PROPOSAL FOR DRAFT AMENDMENTS TO REGULATION No. 52
(Proposed by the Spanish delegation)

Figure 20

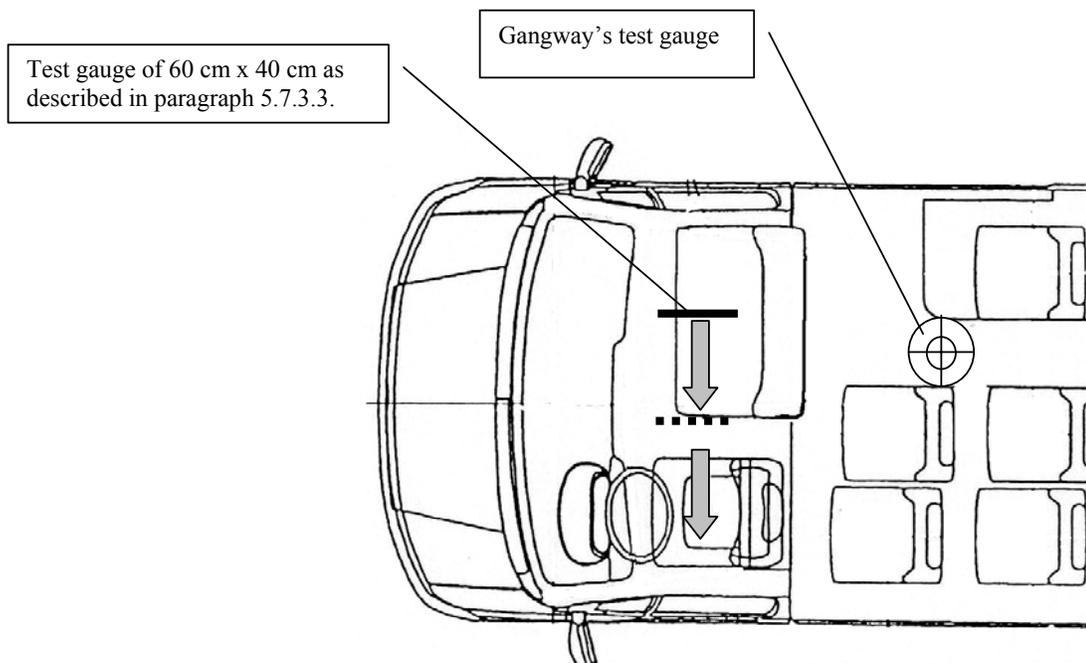
Paragraph 5.6.2.5.2., amend to read

"5.6.2.5.2. The driver's door shall be accepted as the emergency door for the occupants of the seats situated beside the driver's seat **provided that it is possible to move a test gauge from the occupants' seats to the exterior of the vehicle through the driver's door (see annex 3, figure 20).**

Verification of the access to the driver's door shall be subject to the requirements of paragraph 5.7.3.2., by using the test gauge having a dimension of 600x400 mm, as described in paragraph 5.7.3.3. The service door provided for the passengers shall be in the side of the vehicle opposite to that containing the driver's door and shall be accepted as the emergency door for the driver;"

Figure 21
Access to driver's door
(See paragraph 5.7.2.4.2.)

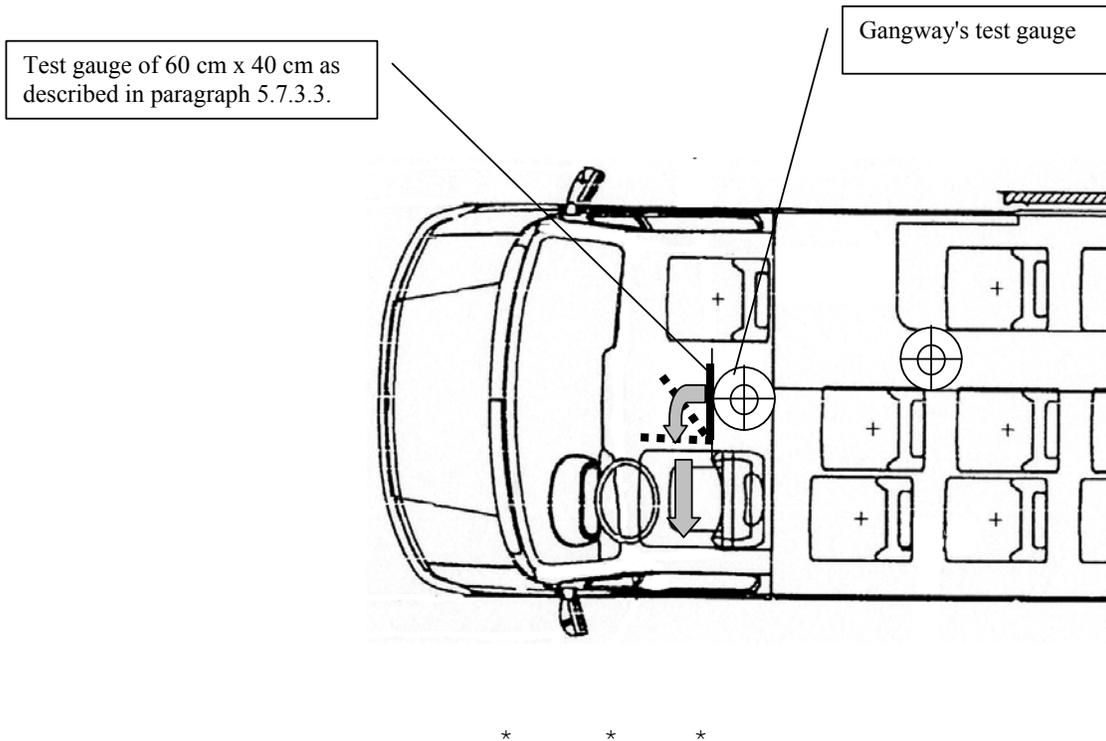
Paragraph 5.7.2.4.2, amend to read

" defined in paragraph 5.6.2.5.2. and that the space reserved to the driver's seat shall communicate with the main passengers' compartment through an appropriate passage; such requirement shall be deemed to be fulfilled if the test gauge described in paragraph 5.7.5.1. can move unobstructed from the gangway, enabling that the front end of the gauge reaches the vertical plane tangential to the foremost point of the driver's seat back (situated this seat in its rearmost possible position) and, from this plane, the panel described in paragraph 5.6.2.5.2. could be moved to the emergency door in the direction established by such paragraph (see annex 3, figure 21)."
